WINDOW & ENTRANCE REPLACEMENT

**BOOTH HILL ELEMENTARY SCHOOL
544 BOOTH HILL ROAD
TRUMBULL, CT 06484
STATE PROJECT #144-0105 EC/CV
RFP #6301**

S/P+A PROJECT NO. 18.089

DATE: August 3, 2018

SCALE: 1/16" = 1'-0"

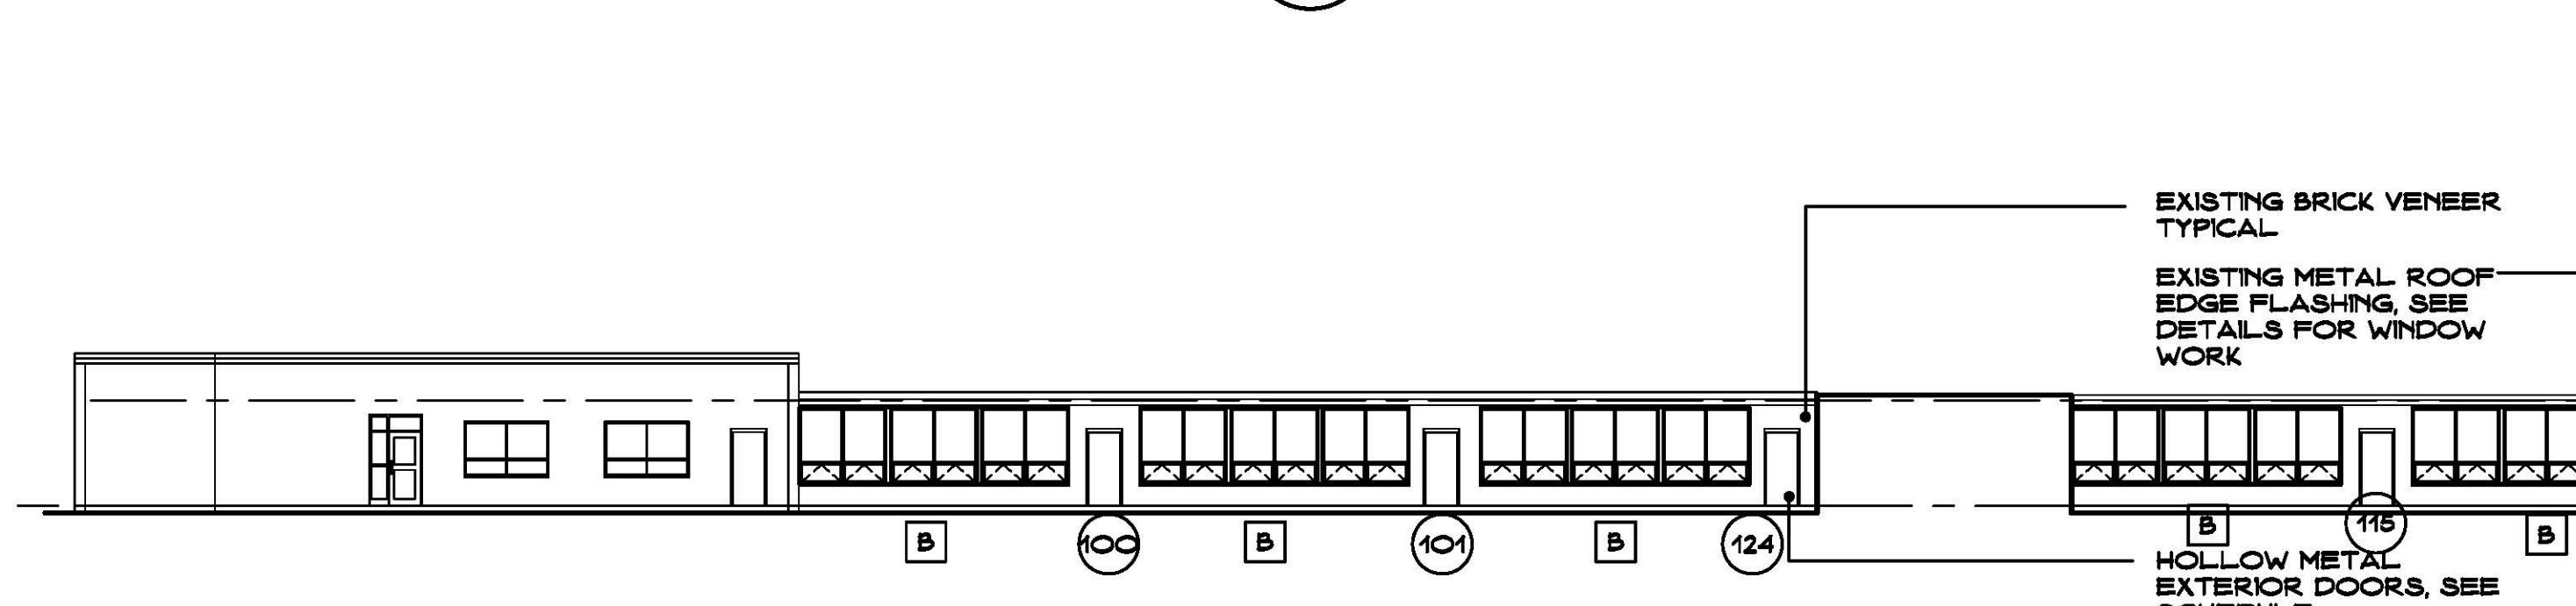
Q6: The floor plan and the elevations have different labels for the windows, what is correct the floor plan or the elevation?

Q7: The floor plan and elevations indicate more doors than the door schedule show, what is correct?

A6: Refer to the revised Drawing A4 included within this addendum.

A7: Refer to the revised Drawing A4 included within this addendum.

“Window Blinds:
-Reinstall on new wood trim. Provide Add Alternate for new blinds. See proj. man.” *(Per Owner/RFI Q8)*
- DRAWING A4, EXTERIOR ELEVATIONS has been deleted in its entirety. A new DRAWING A4 has been added and is attached as part of this addendum.* *(Per RFI Q6)*
- DRAWING A9, SCHEDULES & DETAILS, Door Schedule, Door 129, Door Type, revise “3” to read “1”. *(Per RFI Q6)*
